Replacing the Morr/Pulsafeeder 3 wire electrode with the Advantage part TE-3A

The Advantage Controls conductivity electrode part number TE-3A is a direct replacement for the Morr/Pulsafeeder part TE-2A.

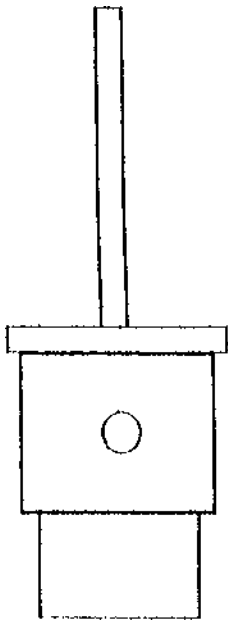
The mounting tees for the two electrodes are different, so a change must be made to the piping. Electrically both parts are identical. All that is required is that the wiring color code be matched up as per the diagram below.
